Southern Nuclear Operating Company
Vogtle Electric Generating Plant Units 3 and 4
Request for License Amendment and Exemption:
Updates to Tier 1 Table 2.5.2-3 (LAR-18-010)

Vogtle Electric Generating Plant (VEGP) Units 3 and 4

Updates to Tier 1 Table 2.5.2-3

**Proposed Changes to the Licensing Basis Documents
(LAR-18-010)**

UFSAR Figure 7.2-1, Sheet 12

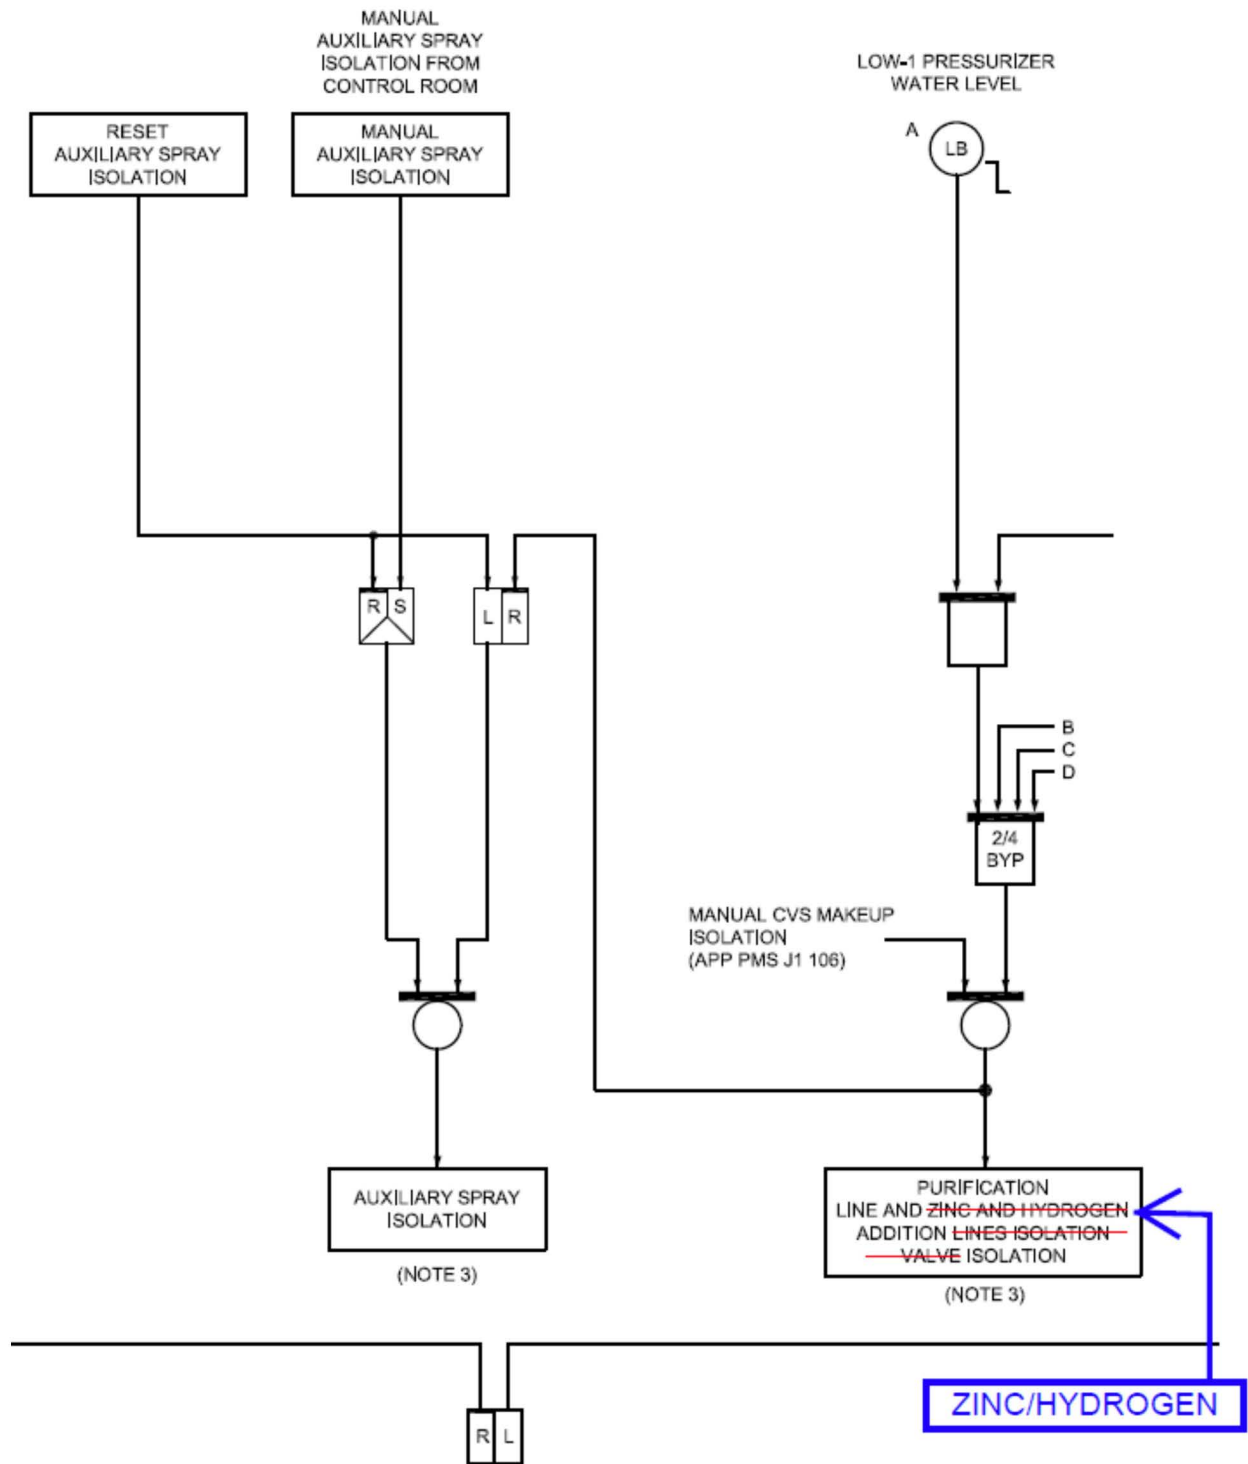
As part of the LAR 13-002 changes, UFSAR Figure 7.2-1 (Sheet 12) currently identifies the signal as "Purification Line and Zinc and Hydrogen Addition Lines Isolation Valve Isolation." This naming convention does not match the naming convention found in design documentation for this signal. CVS design documentation refers to the signal as "Purification Line and Zinc/Hydrogen Addition Isolation." Therefore, it is proposed to editorially change UFSAR Figure 7.2-1 (Sheet 12) to match this nomenclature. This editorial change is proposed to align UFSAR Figure 7.2-1 (Sheet 12) with the nomenclature used in supporting design documentation.

Although LAR 13-002 revised the nomenclature shown on UFSAR Figure 7.2-1 (Sheet 12), several other references to this signal require consistent nomenclature changes. UFSAR Subsection 7.3.1.2.15, Subsection 7.3.1.2.18, UFSAR Table 7.3-1, and TS Bases 3.3.8 contain references to the name of the signal as "Letdown Purification Line Isolation" or "Purification Line Isolation." In order to maintain consistency with the updated nomenclature as proposed in UFSAR Figure 7.2-1 (Sheet 12), it is proposed to revise each location to consistently reference "Purification Line and Zinc/Hydrogen Addition Isolation."

- UFSAR Figure 7.2-1 (Sheet 12), is changed to add “and Zinc/Hydrogen Addition” to the “Purification Line Isolation” signal.
- UFSAR Subsection 7.3.1.2.15 changes the name of “Auxiliary Spray and Letdown Purification Line Isolation” to be “Auxiliary Spray and Purification Line and Zinc/Hydrogen Addition Isolation.”
